ADDENDUM NO. 1
REVISIONS TO BE INSERTED
ONTO 'BID SET' DWG. NO. S1.1

RECONSTRUCT TOWER APRON (APPROX. 850 LF X 250 LF)
BOIRE FIELD – NASHUA MUNICIPAL AIRPORT – NASHUA, NEW HAMPSHIRE
SBG NO. 12–03–2009

DATE:	MAY 1, 2009
SCALE:	AS SHOWN
REVISION:	ADDENDUM NO. 1

S1.1A

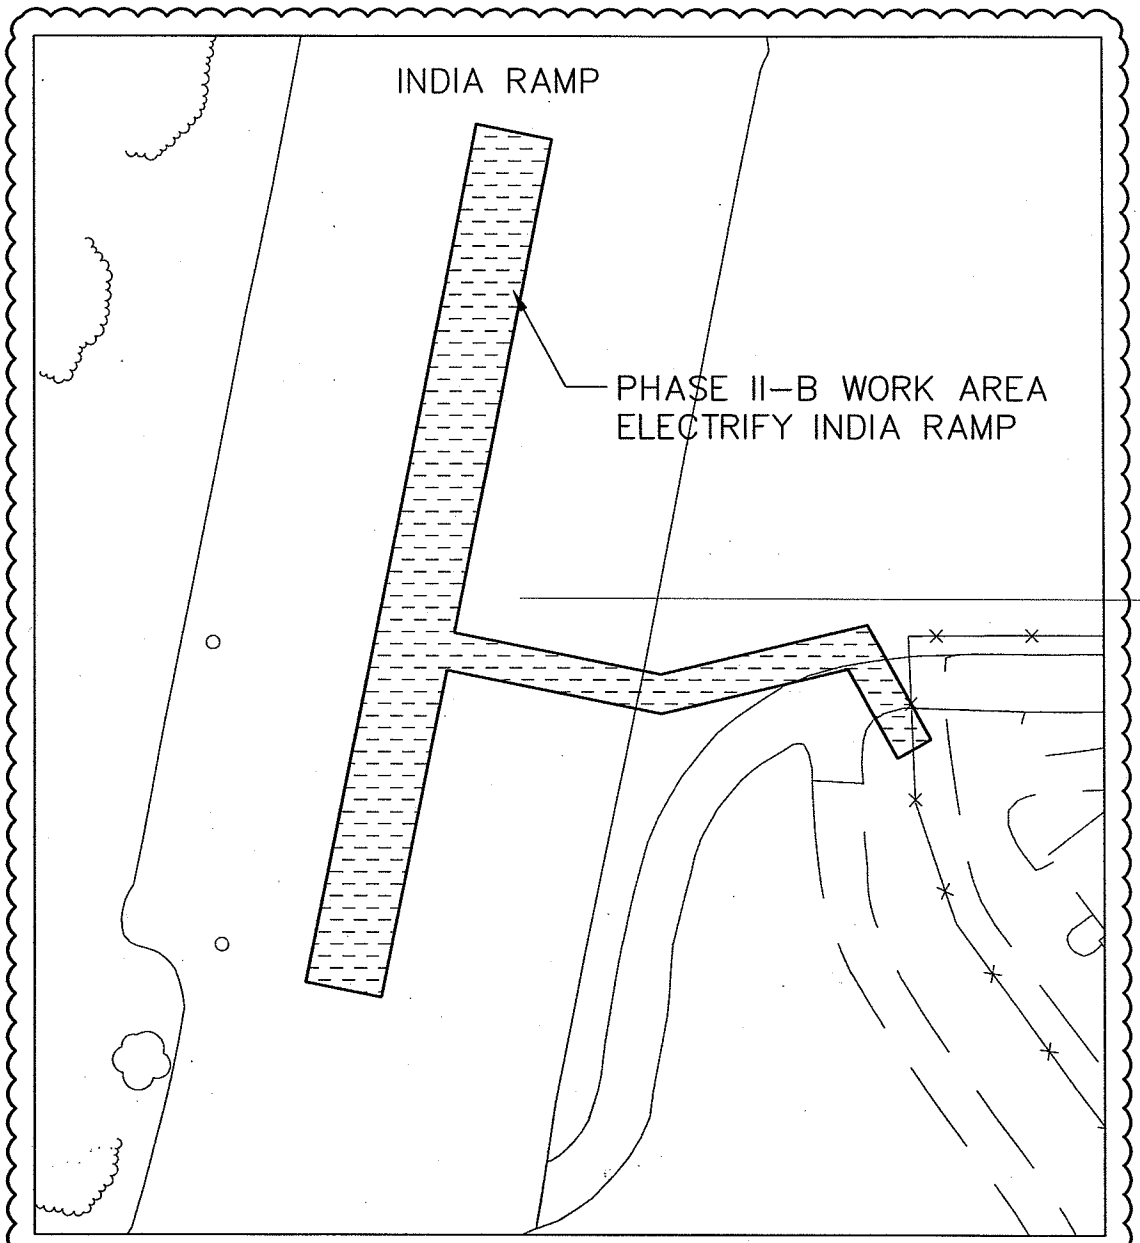
1 PHASE II–B MAP 1

S1.1C

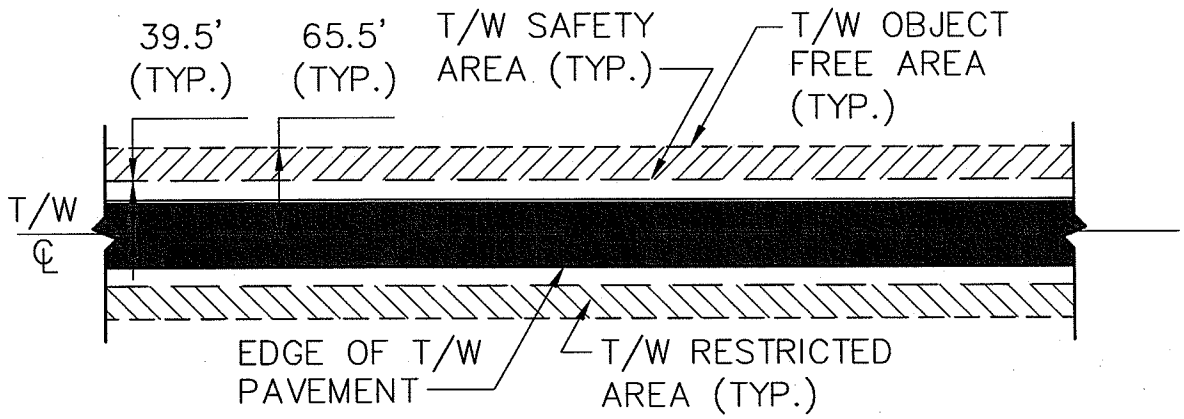
⚠1 TAXIWAY/TAXILANE RESTRICTED ⚠1 CONSTRUCTION AREAS

C3.2A

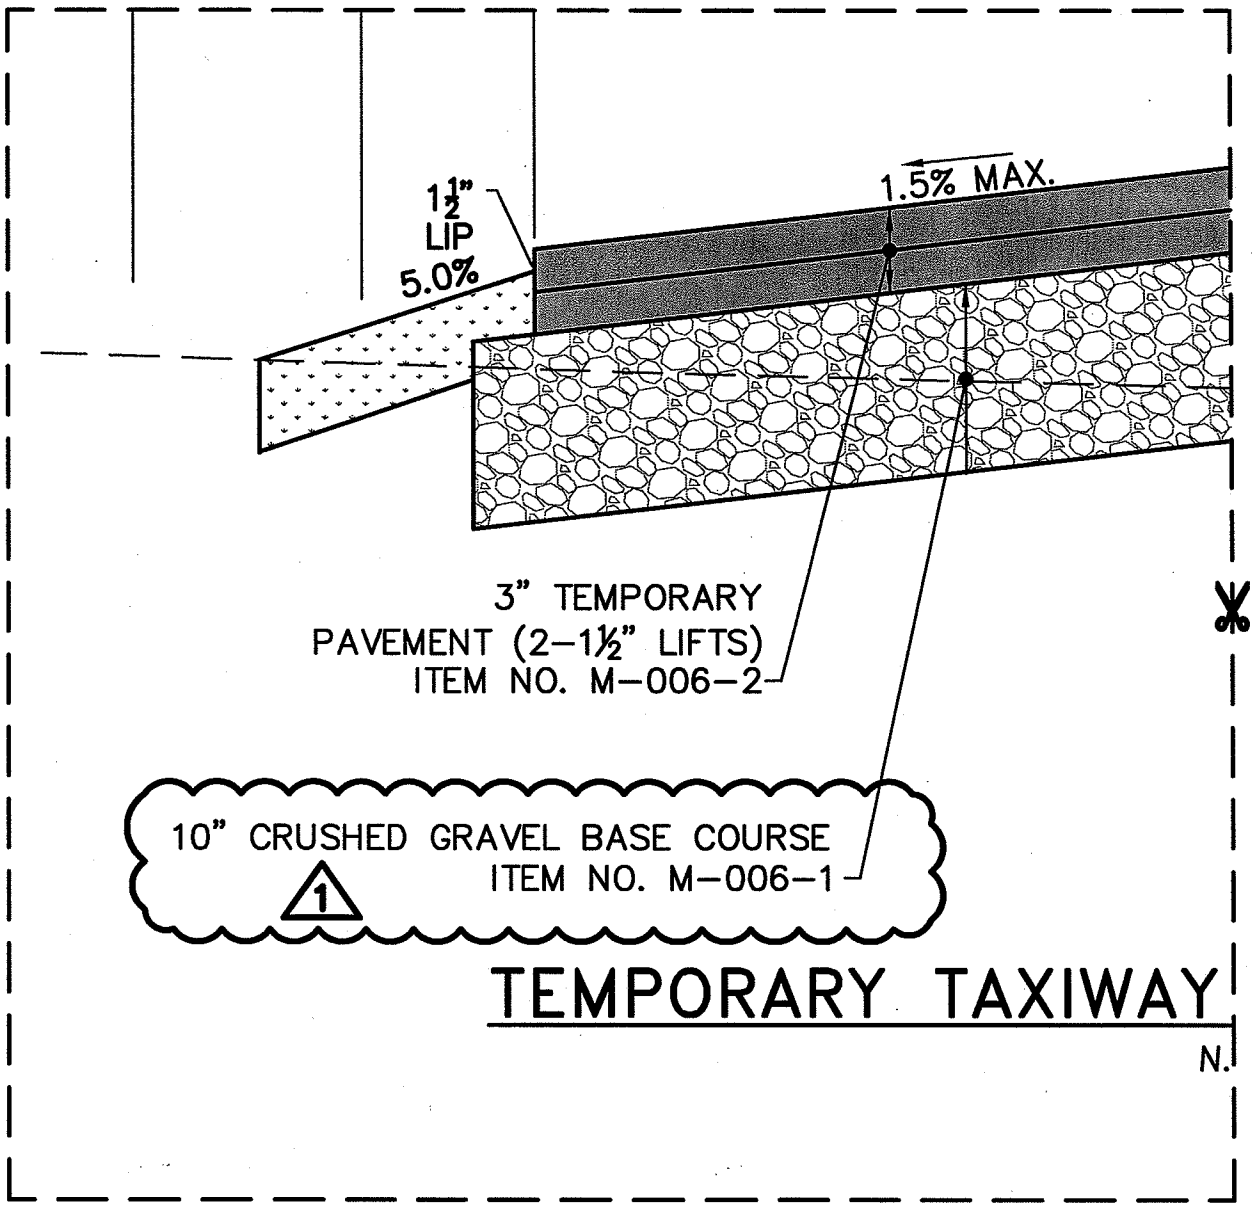
1. ALL PREFABRICATED REINFORCED CONCRETE STRUCTURES AND FRAME AND GRATES SHALL BE DESIGNED AND CONSTRUCTED TO SUPPORT A 175,000 LB DUAL WHEEL LOAD. THE CONTRACTOR IS REQUIRED TO SUBMIT SHOP DRAWINGS AND MANUFACTURER CERTIFICATIONS TO THE ENGINEER FOR REVIEW PRIOR TO INSTALLATION. SHOP DRAWINGS FOR LOADING SHALL BE STAMPED BY A PROFESSIONAL ENGINEER LICENSED IN NEW HAMPSHIRE.

2. A GRADE RING OR BRICKS ARE REQUIRED. IF BRICKS ARE USED A MINIMUM OF TWO (2) TO A MAXIMUM OF FOUR (4) COURSES ARE REQUIRED. THE GRADE RING SHALL BE A MINIMUM OF SIX (6) INCHES TO A MAXIMUM OF TWELVE (12) INCHES.

C3.2B

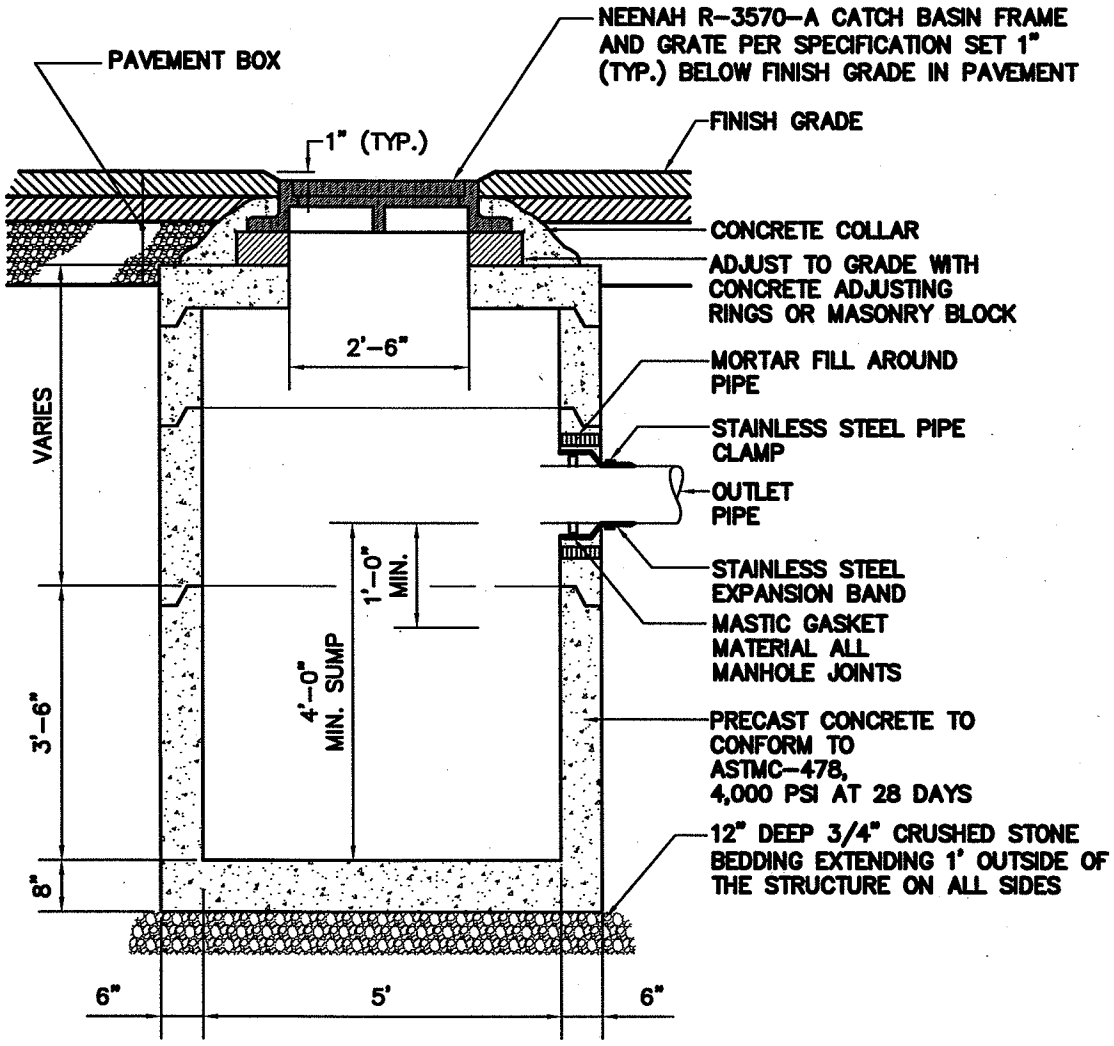
1. FOR DRAINAGE LAYOUT SEE DWG. NO. 3.1
2. ALL PREFABRICATED REINFORCED CONCRETE STRUCTURES AND FRAME AND GRATES SHALL BE DESIGNED AND CONSTRUCTED TO SUPPORT A 51,000 LB SINGLE WHEEL LOAD. THE CONTRACTOR IS REQUIRED TO SUBMIT SHOP DRAWINGS AND MANUFACTURER CERTIFICATIONS TO THE ENGINEER FOR REVIEW PRIOR TO INSTALLATION. SHOP DRAWINGS FOR LOADING SHALL BE STAMPED BY A PROFESSIONAL ENGINEER LICENSED IN NEW HAMPSHIRE.

C4.1A

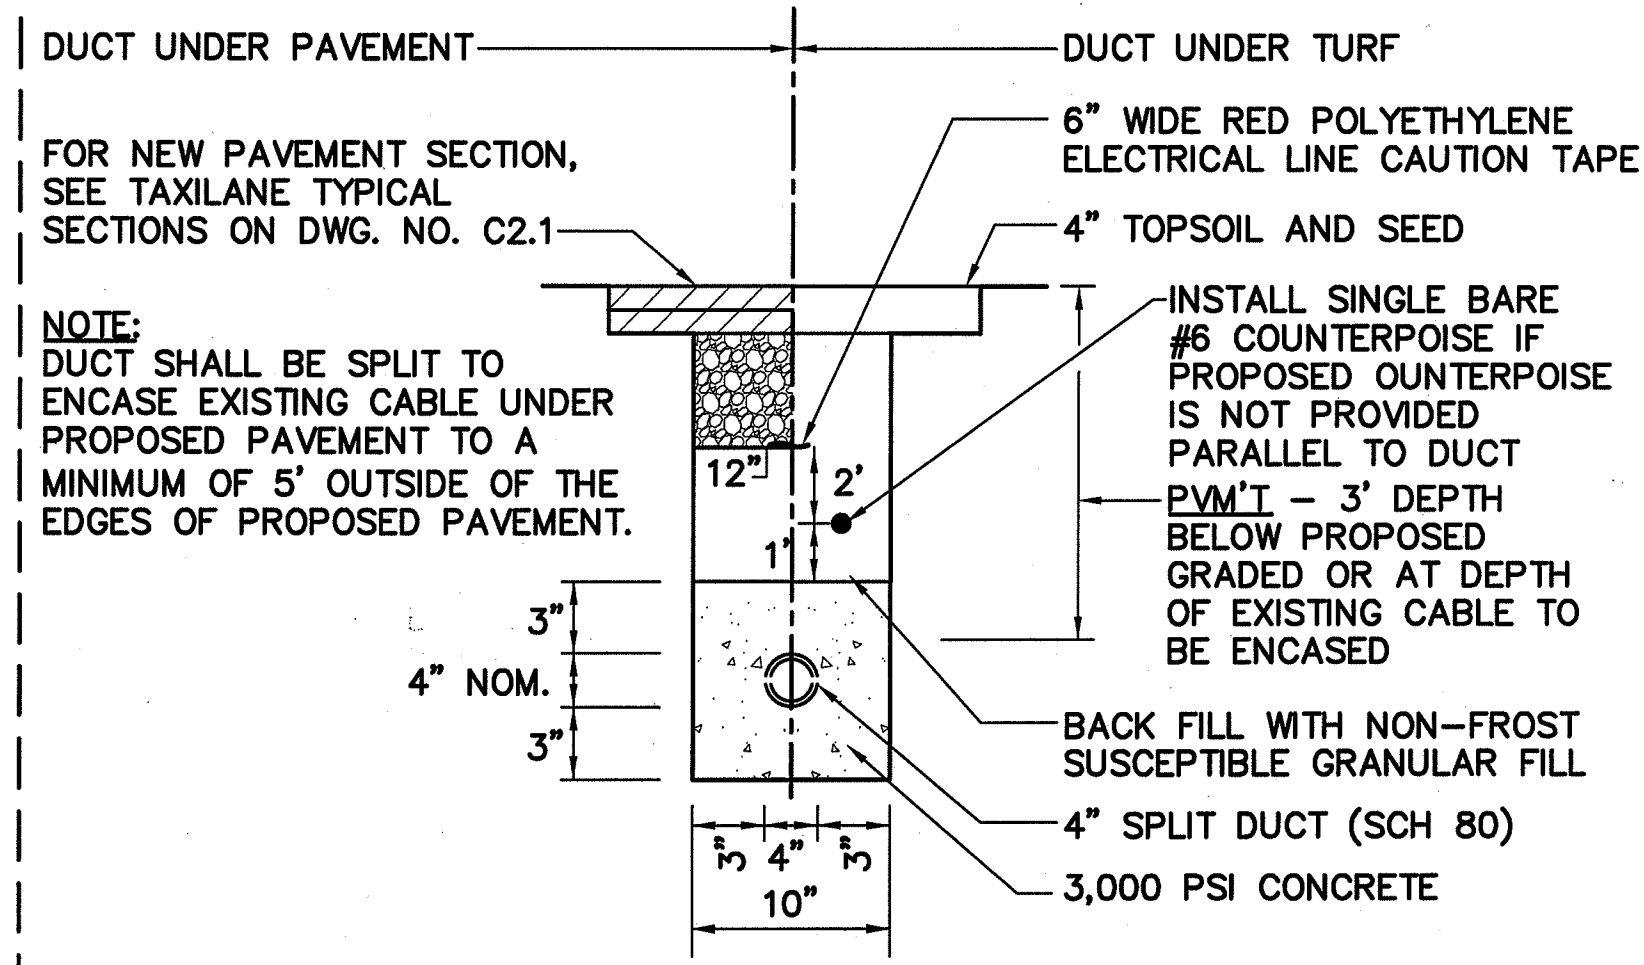
FOR NEW PAVEMENT SECTION, SEE TAXILANE TYPICAL SECTIONS ON DWG. NO. C2.1

NOTE:
DUCT SHALL BE SPLIT TO ENCASE EXISTING CABLE UNDER PROPOSED PAVEMENT TO A MINIMUM OF 5' OUTSIDE OF THE EDGES OF PROPOSED PAVEMENT.

L1.3A

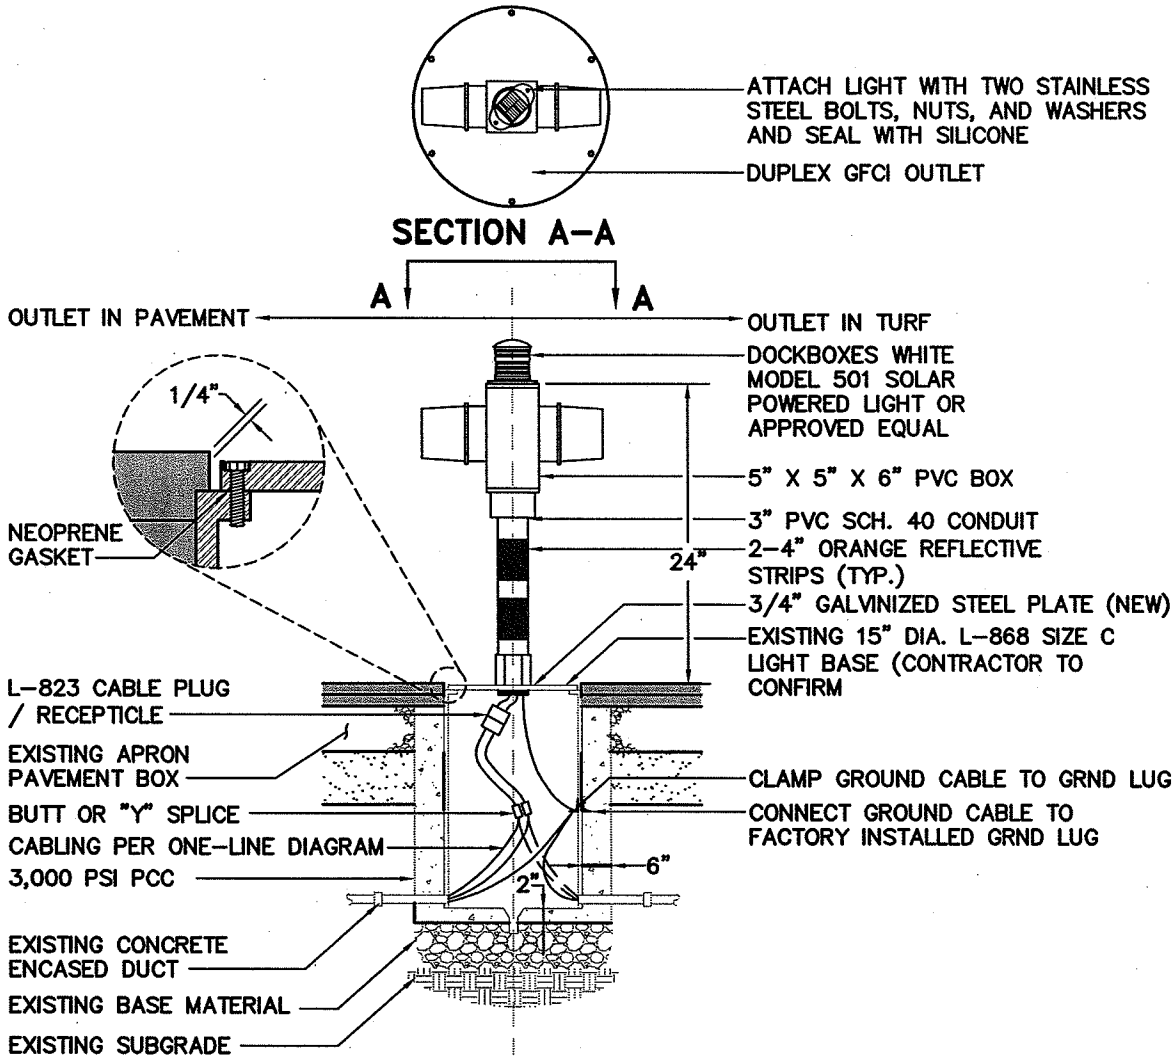
1. THE SPLICE SHALL BE WATERPROOF CAST RESIN TYPE.
2. THE CABLE PLUG SHALL BE WATERPROOF. IN ADDITION, THE CONTRACTOR SHALL SUPPLY A "DUMMY PLUG" TO COVER CABLE RECEPTICLE WHEN NOT IN USE.
3. THE GROUND LUG(S) ARE TO BE FACTORY INSTALLED ONLY.
4. SUFFICIENT CABLE SLACK SHALL BE PROVIDED IN EACH LIGHT BASE TO ALLOW FOR MAINTENANCE AT PAVEMENT SURFACE.
